FIELD CHANGE

Field Change #: (obtained and completed by DEL after form has been completed by initiator)	13720-FC-00018	**Revision:**	R00	**Date:**	27-Sep-2013

FC Title: (completed by initiator)	EC 123123 R01 FIC 04 Support Anchor Electrical Interferences Located Flanged Fitting Bolting Materials and Torque Values Required
Design EC #: (completed by initiator, only one DEC per FC)	123123 – HWMB Dewatering TMOD
Project #: (completed by initiator)	B&M Project # 48070014, RCMT Project 13720
Description of Change: (completed by initiator)	1. OPG FE has scanned the areas prior to anchor install for the pipe supports, there are numerous electrical interferences in the area where the vertical riser meets the roof. OPG FE have requested that we avoid anchoring into the entire area from where the overhang is North to the grating. Therefore, the first two HG3 style supports after our pipe meets the roof running north will not be able to be anchored to the roof. Suggest using a steel base plate welded to these supports with the use of sandbags to secure the supports that cannot be anchored. 2. The flange specified (DBOM item 4) will require the addition of a gasket, studs and nuts to the DBO

dwg no NK38-DRAW-12320-10001

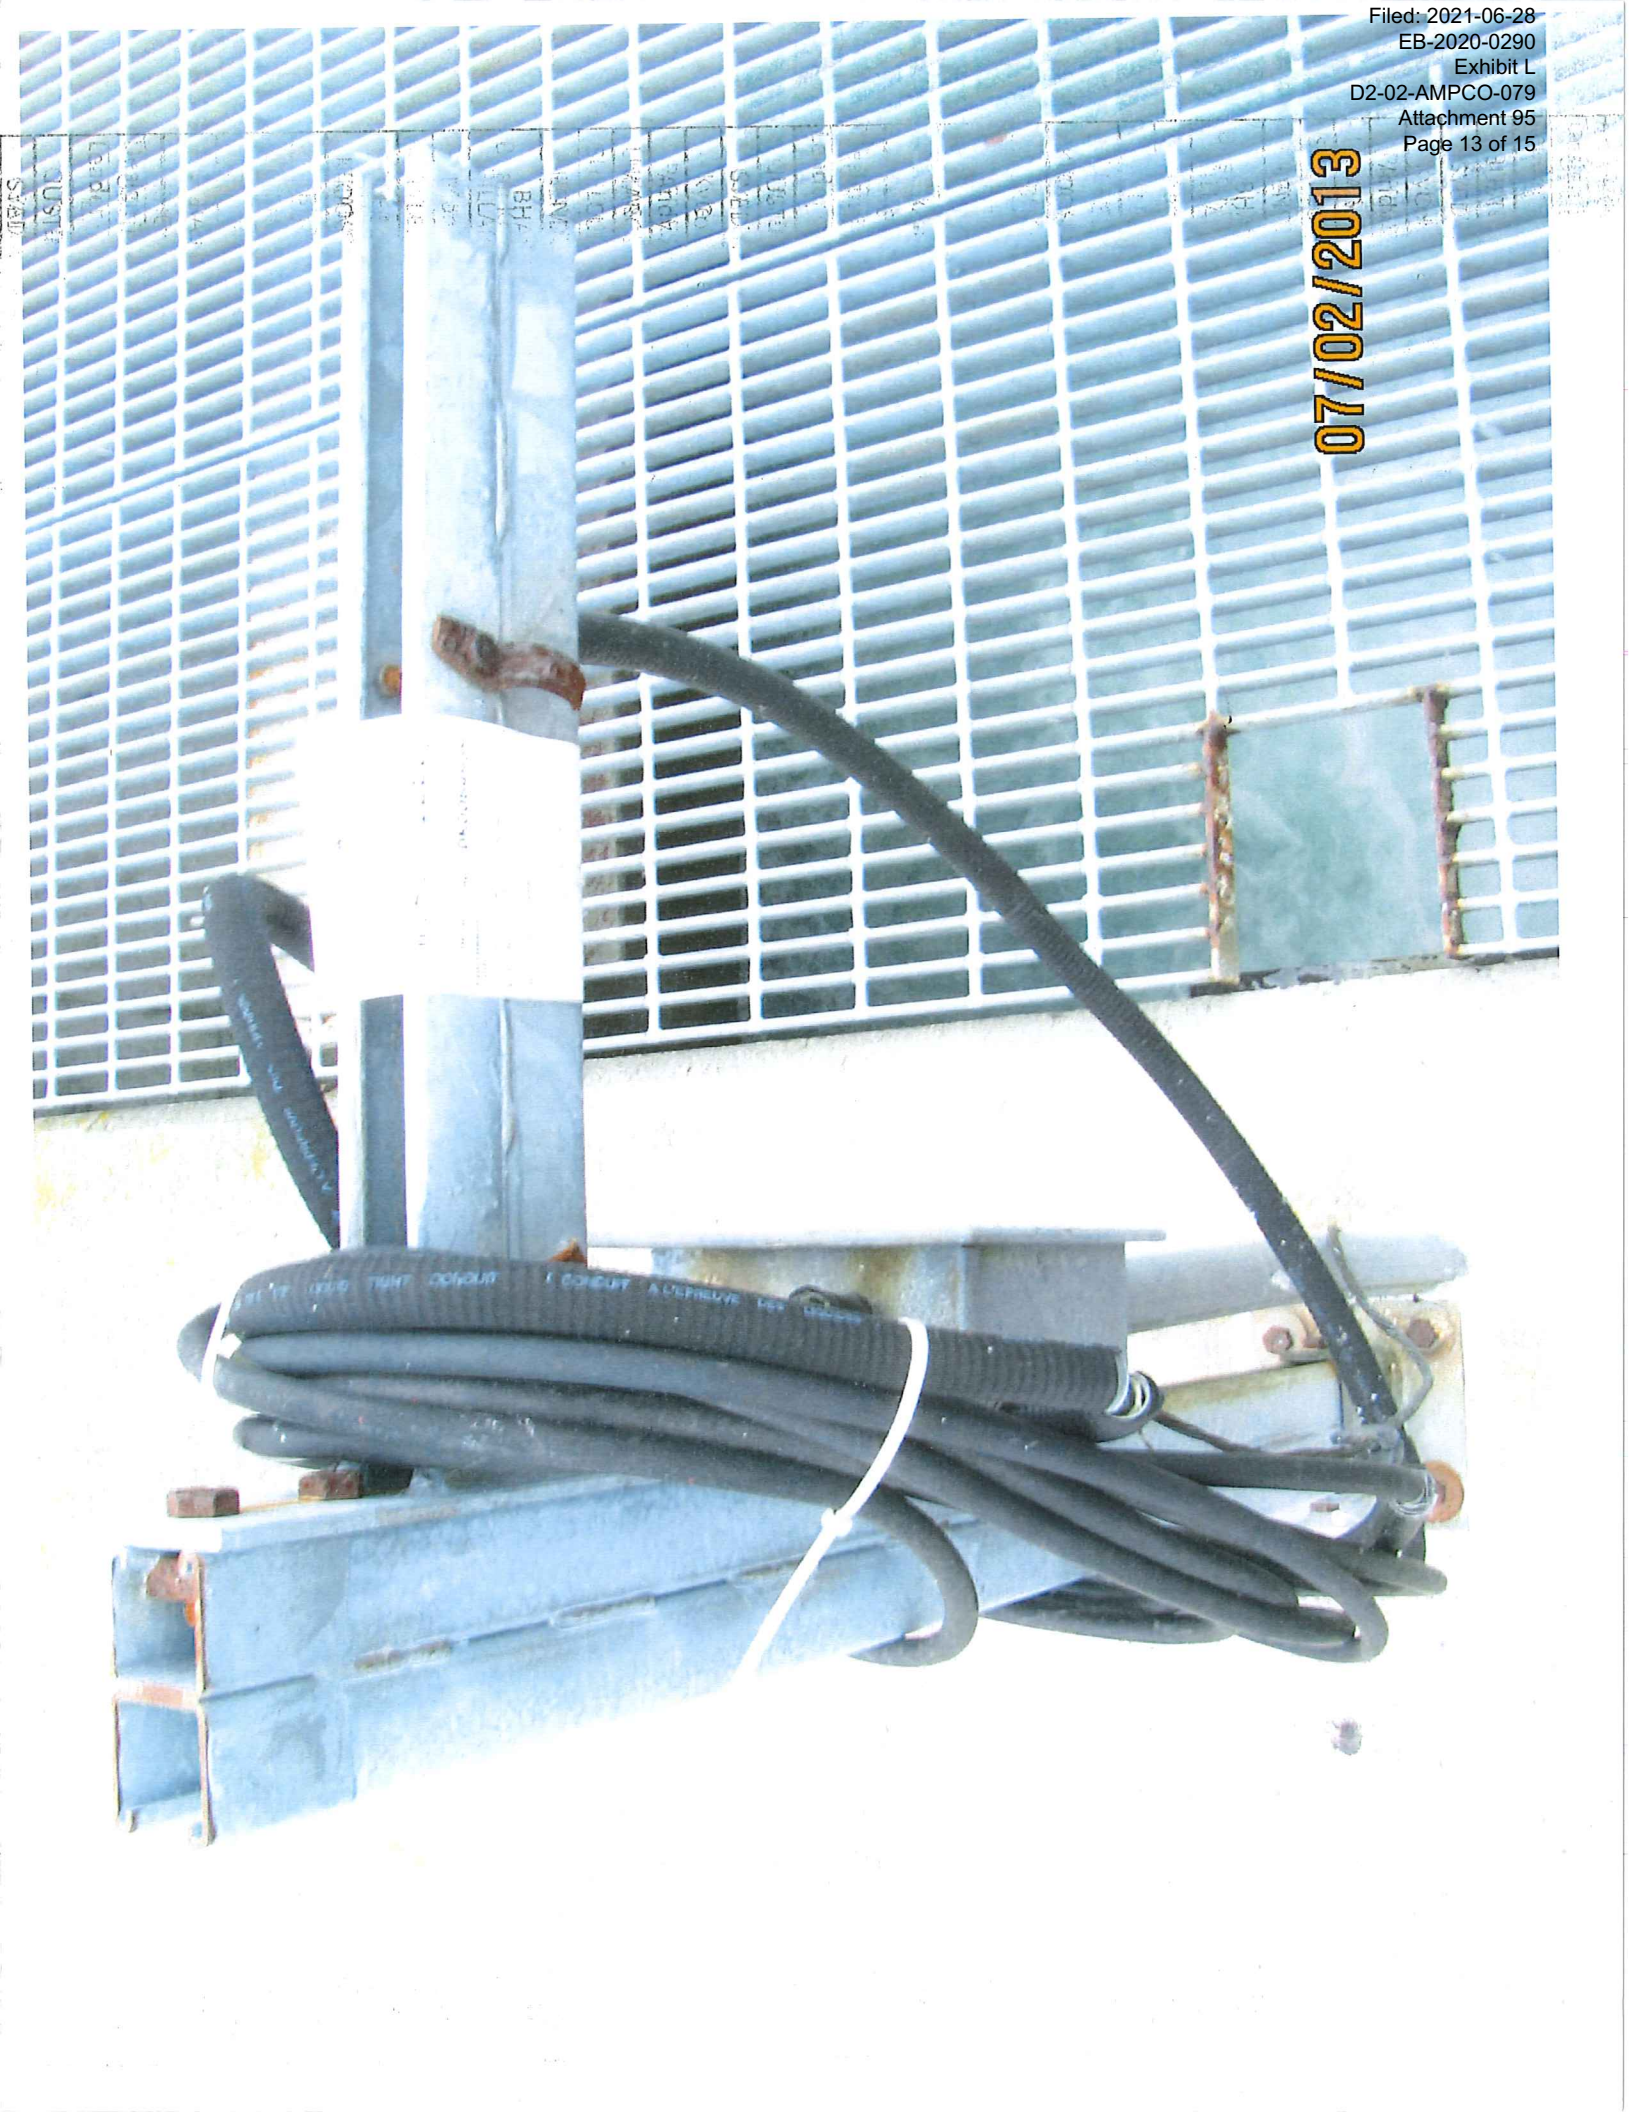
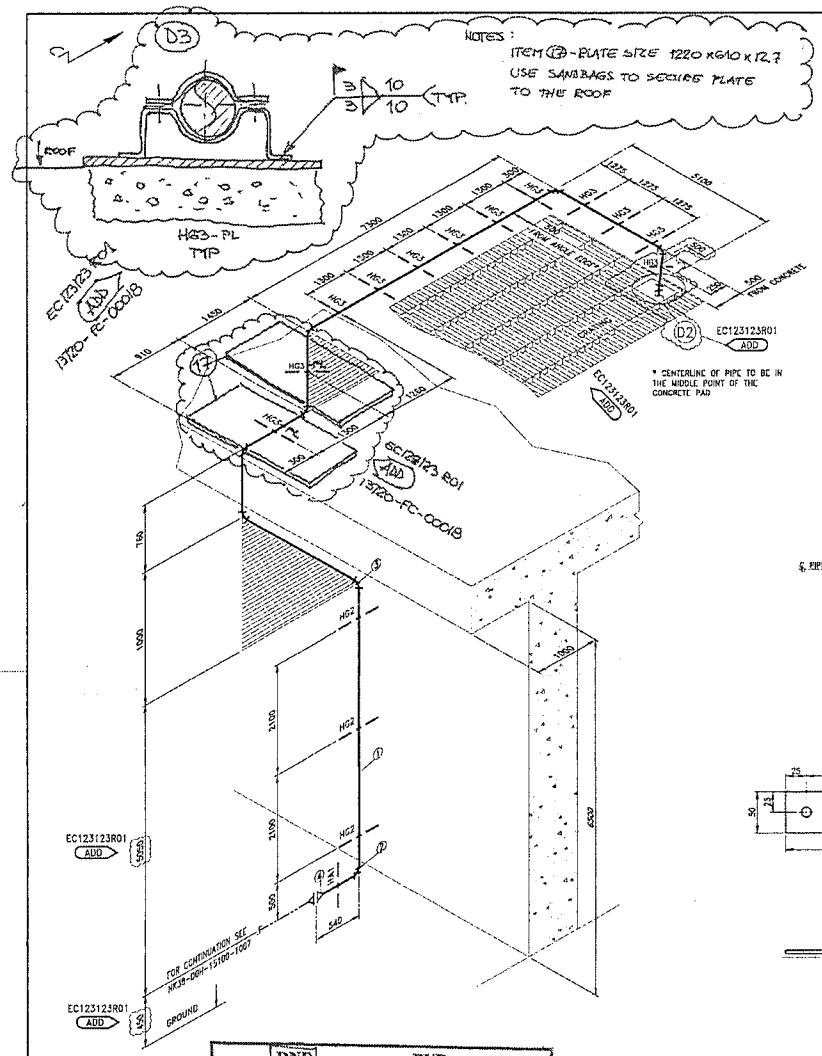
EC123123R01 (ADD) 13720-FCL-00018

NOTES:
ITEM 13 - PLATE SIZE 1220 x 610 x 12.7
USE SANDBAGS TO SECURE PLATE TO THE ROOF

2. Aquatech will provide gasket and required fasteners. DBOM update is not required.

3. Use of NK38-MMP-76550-06 is acceptable.
